TPB Ref.: A/NE-HLH/68

**Proposed Temporary Warehouse and Open Storage of Construction Machinery & Construction Material for a Period of 3 Years at Lots 171 (Part), 172 (Part), 176 (Part) & 177 (Part) in D.D. 87, Ta Kwu Ling, New Territories**

Our response to the further comments of the CE/MN, DSD is as follows:

**Annex 1 Drainage Proposal**

Photo 1

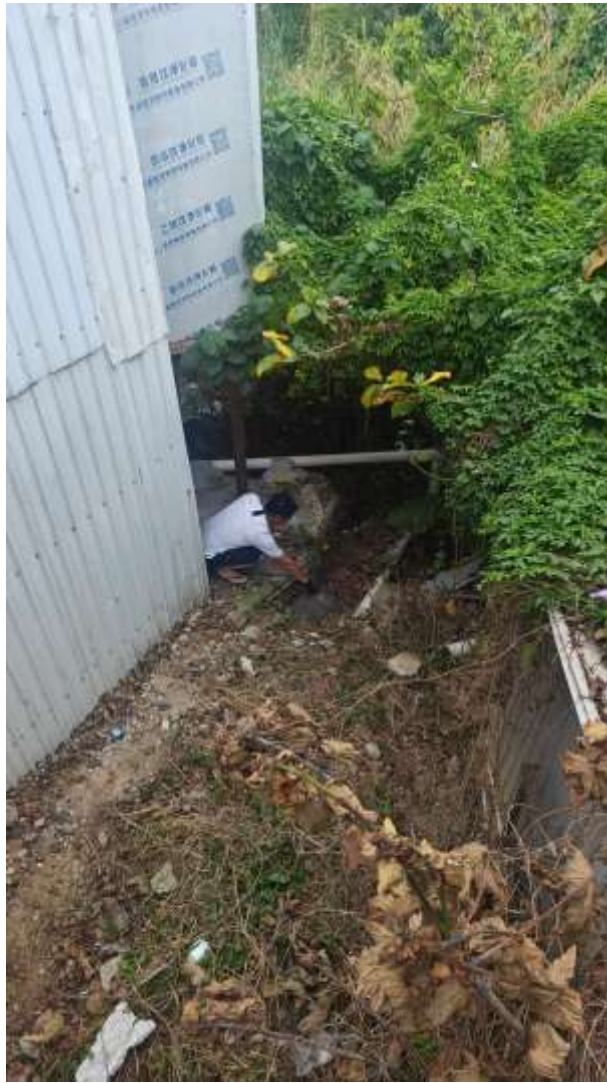
CE/MN, DSD's comments	Applicant's response
(a) Please provide photo at the discharge point and the downstream existing watercourse.	Noted. Please see attached photo in the following. The photo viewpoint is found in updated drainage plan in the attachment (Figure 4)

Photo at the discharge point and the downstream
